**COMMISSION OF ARCHITECTURAL REVIEW  
STAFF REPORT  
May 22, 2018, Meeting**

10. **COA-034575-2018** (Dobrin Homes)

**617 West 21<sup>st</sup> Street  
Springhill Old and Historic District**

**Project Description:** **Construct a new single family dwelling.**

1950 Sanborn Map

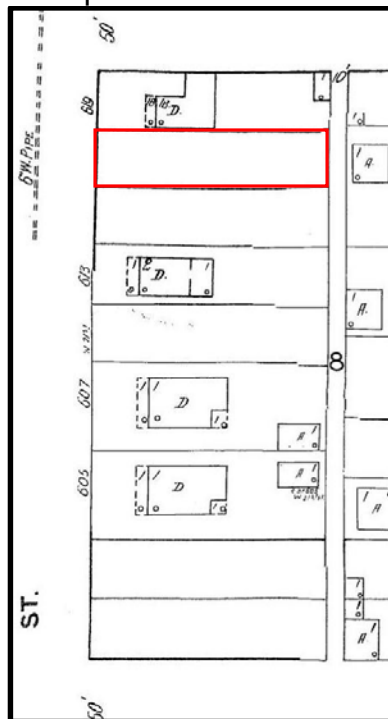
**Where the adjoining buildings have different setbacks, the setback for the new building should be based on the historical pattern for the block**

The historical pattern of the block is consistent with the setback pattern of the historic structures on the block as it appears half of the block including the subject lot was not developed. The proposed substantial front yard setback is consistent with the structure at 619 West 19<sup>th</sup> and the pattern found in the district.
